CITY OF SAUSALITO
420 Litho Street, Sausalito, CA 94965

Addendum No. 1

For
Dunphy Park Soil Stockpile Removal Project

Dunphy Park Soil Stockpile
 Figure 3
 Removal Project Addendum 1
 Page 5

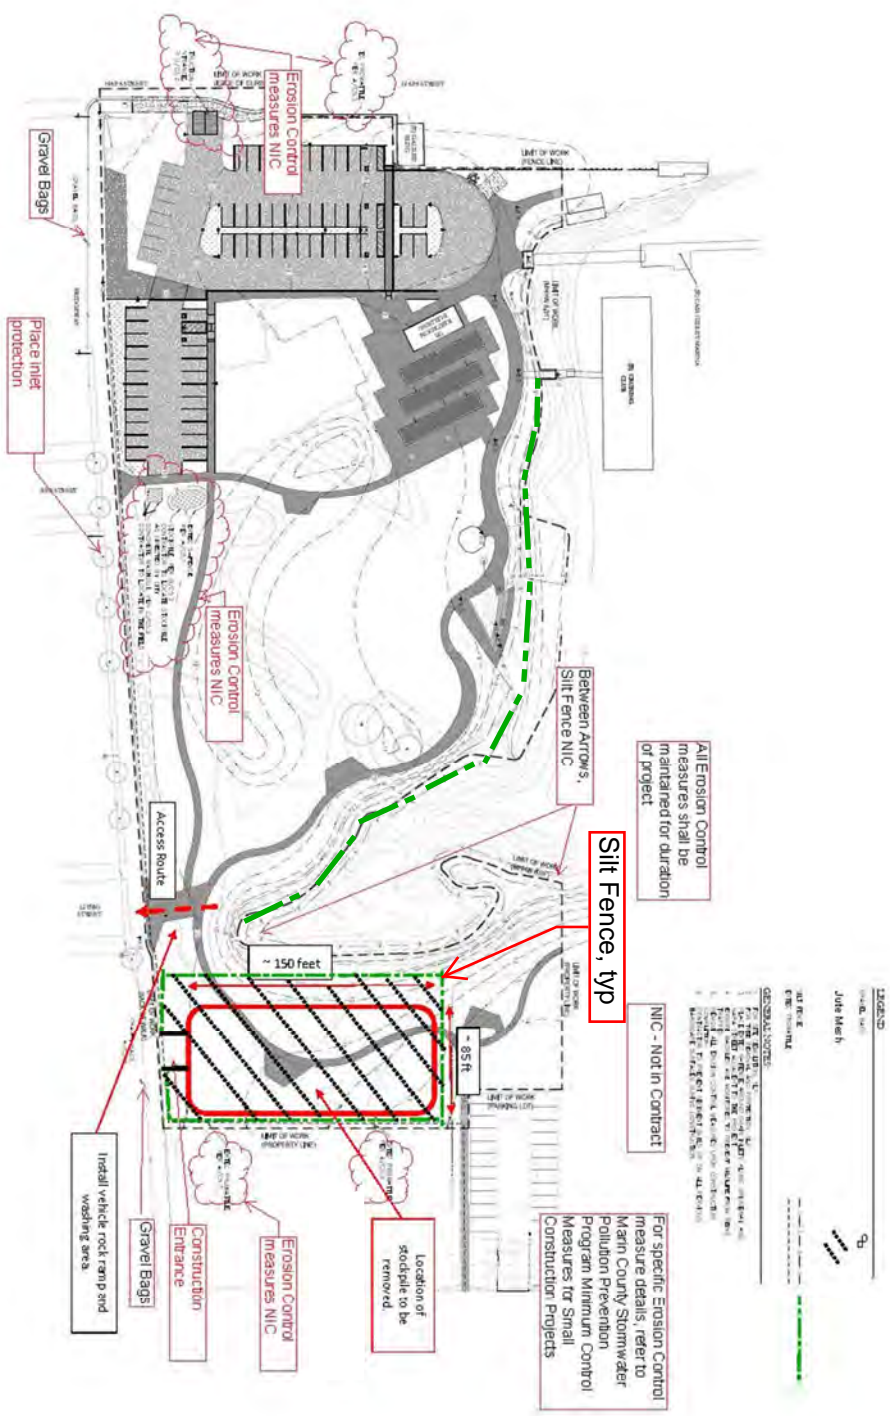
Replace Figure 3 Stockpile Soil Removal and Erosion Control Plan **with** figure attached to this Addendum No. 1

On the "Stockpile Soil Removal and Erosion Control Plan" it appears the contractor must install a rock entrance and exit and DI protection and gravel bags in the gutter area

- a. Is there anything else required pertaining to erosion control materials?
b. I can see that the Marin County Stormwater Pollution Prevention document is referenced, however this document is generic, and I want to make sure I have an understanding of the project specific requirements

- a. Is this in the shoreline area, the stockpile area, or both?
- b. Is this in lieu of, or in addition to, hydroseed?

- a. Refer to "Dunphy Park Soil Stockpile Removal Project Addendum 1, attached to this Addendum No. 1, which includes but is not limited to: silt fence, Inlet protection, gravel bags, vehicle rock ramp and washing area, jute mesh.
b. Cited document provides details/reference to details for erosion control measures and their installation.

- a. Refer to "Dunphy Park Soil Stockpile Removal Project Addendum 1, attached to this Addendum No. 1 where the location of jute mesh is shown.
- b. Refer to Response to Question 1 of this Addendum No. 1.
